ROOT-MOORE GARDEN ESTATES SUBDIVISION

APPLICATION NUMBER 18 DATE June 17, 2004
APPLICANT Root-Moore Garden Estates Subdivision
REQUEST Subdivision

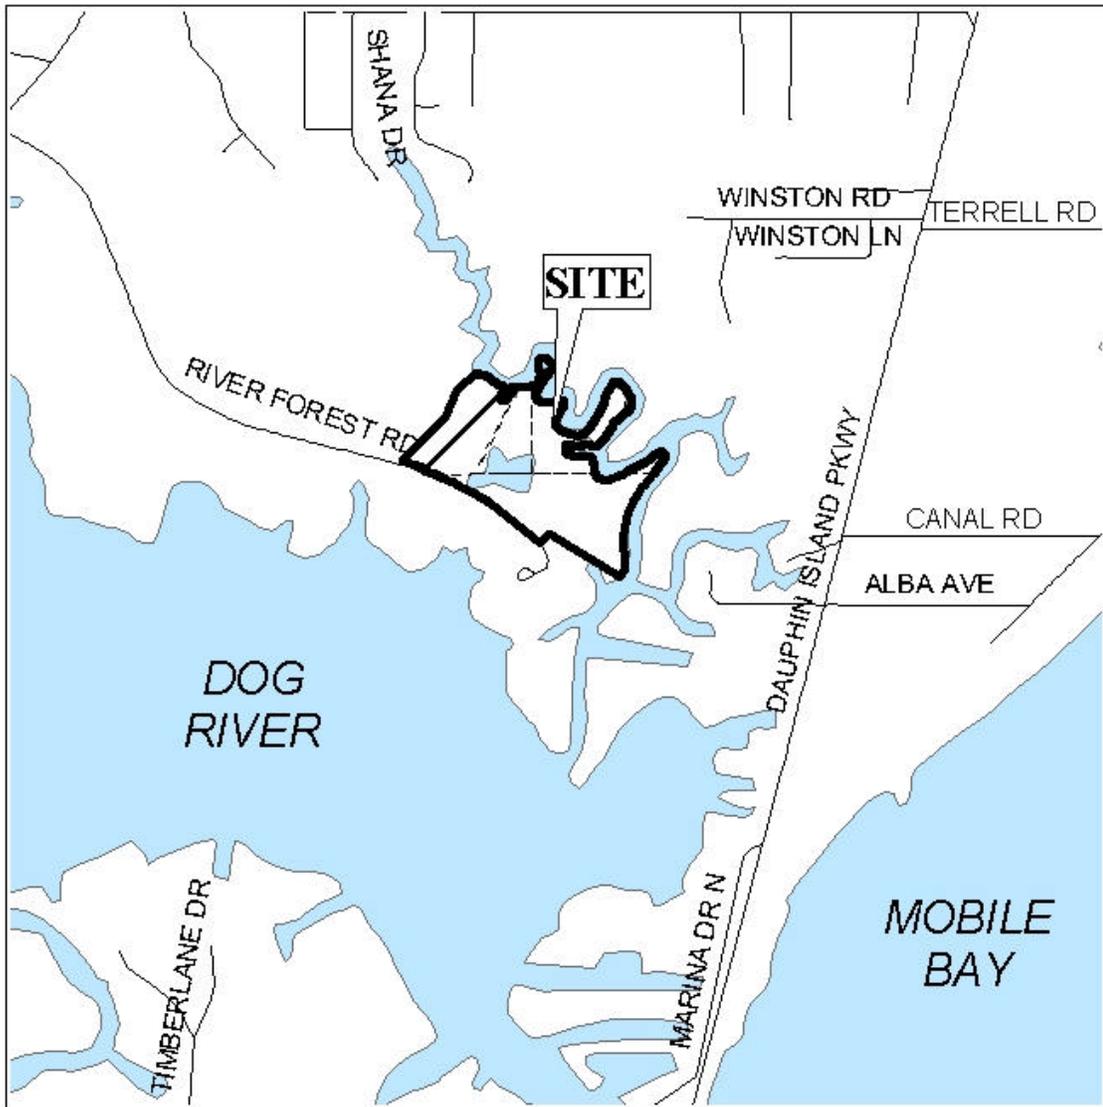
The site exceeds the maximum width to depth ratio as recommended by the Subdivision Regulations; therefore, a waiver of Section V.D.3., would be required. Narrow, deep lots are typical along waterways and would conform with the surrounding development patterns, thus the waiver would be appropriate.

The 25-foot minimum building setback lines are not shown but would be required on the final plat.

The site fronts River Forest Road and the plat illustrates that the right-of-way is variable. A standard city street requires a minimum right-of-way width of 50-feet. Therefore, the dedication of any necessary right-of-way to provide 25-feet from the centerline of River Forest Road should be required.

As illustrated on the Vicinity Map, there are three existing homes on the site; two dwellings on Lot 2 and one home on Lot 1. The site is zoned R-1, Single-Family Residential and as such only one home is allowed on a single lot; therefore, the submission of documentation to establishes these dwellings as legal nonconforming uses prior to 1967 (when the Zoning Ordinance was adopted) would be required prior to the recording of the final plat.

Additionally, it appears that one of the dwellings may encroach upon the proposed lot line. The lot line should be shifted to provide an adequate setback from all structures or the structure(s) should be removed prior to final approval.

With a waiver of Section V.D.3. (width to depth ratio), the plat will meet the minimum requirements of the Subdivision Regulations and is recommended for Tentative Approval subject to the following conditions: 1) dedication of any necessary right-of-way to provide 25-feet from the centerline of River Forest Road; 2) the placement of the 25-foot minimum setback lines on the final plat (measured from any necessary dedication); 3) the approval of all applicable federal, state and local agencies; 4) the submission of documentation to establish the existing dwellings as legal nonconforming uses prior to 1967; and 5) that an adequate setback be provided between the new lot line and any structures prior to the recording of the final plat.
